REMARKS

This is in full and timely response to the Office Action mailed on May 16, 2007. Reexamination in light of the following remarks is respectfully requested.

Claims 23-29 are present in the above-identified application, with claim 23 being independent. *No new matter has been added.*

FIG.17

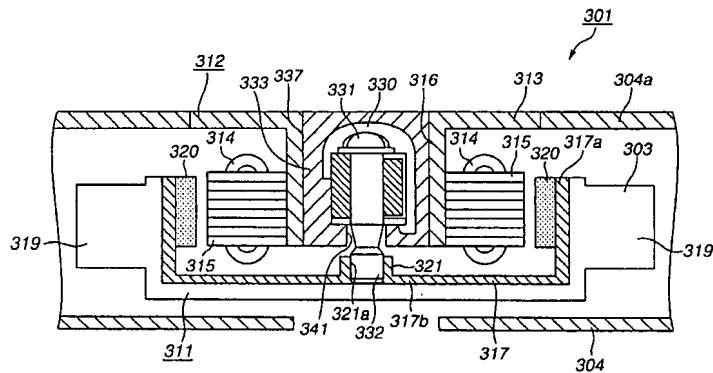
The Office Action contends that the term "space-forming member" is confusing (Final Office Action at page 2).

The Office Action questions how can the house be “hermetically sealed” when there is a shaft receiving hole (Final Office Action at page 2).

The Office Action inquires as to the location of the “communication passage way” (Office Action at page 2).

Moreover, claim 23 provides, in part, the features of *a space-forming member arranged outside the radial bearing and the thrust bearing*.

The specification as originally filed, in the paragraph beginning at page 49, line 8, provides that the rotor 311 that forms the motor 301 along with the stator 312 is fitted to the rotary shaft 331 that is rotatably supported by the bearing unit 330 so that it revolves with the rotary shaft 331.

As shown in FIGS. 17, 18 and 19, the bearing unit 330 that rotatably supports the rotary shaft 331 of the above described motor 301 comprises a radial bearing 333 for peripherally supporting the rotary shaft 331, a space-forming member 334 formed outside the radial bearing 333, a housing 337 containing the space-forming member 334 and a communication passage way 350 formed between the space-forming member 334 and the radial bearing 333.

Thus, it is believed that the metes and bounds of a space-forming member within the claims can be readily ascertained.

In response, claim 23 provides, in part, the features of *a housing (337) having the space-forming member (334) in the inside and hermetically sealed except a shaft receiving hole (336a) through which the shaft (331) is made to extend.* In this regard, the specification as originally filed, in the paragraph beginning at page 59, line 9, provides that:

Meanwhile, the bearing unit 330 of this embodiment is a so-called shaft opposite ends open type bearing unit in which the opposite ends of the shaft 331, one of which is projecting from the radial bearing 333, communicate with each other by way of the communication passage way 350. Conventional shaft opposite ends open type bearing units are accompanied by the problem that lubricating oil can easily disperse when subjected to impact. However, in the bearing unit 330 of this embodiment, the housing 337 is made to be a seamless structure that is hermetically sealed except the shaft receiving through hole 336a and contains the radial bearing 333 and the space-forming member 334 in the inside so that, while the open side end of the shaft that projects from the radial bearing and the closed side end of the shaft are made to communicate with each other by way of the communication passage way 350, the bearing unit 330 is hermetically sealed and isolated from the outside except the shaft receiving hole 336a arranged at the housing 337. Differently stated, since the communication passage way 350 is arranged in the housing that is a seamless structure and hermetically sealed against the outside, lubricating oil is prevented from dispersing if it is subjected to impact.

Thus, it is believed that the metes and bounds of hermetically sealed within the claims can be readily ascertained.

As shown in FIGS. 17, 18 and 19, the bearing unit 330 that rotatably supports the rotary shaft 331 of the above described motor 301 comprises a radial bearing 333 for peripherally supporting the rotary shaft 331, a space-forming member 334 formed outside the radial bearing 333, a housing 337 containing the space-forming member 334

and a communication passage way 350 formed between the space-forming member 334 and the radial bearing 333.

Thus, it is believed that the metes and bounds of a communication passage way within the claims can be readily ascertained.
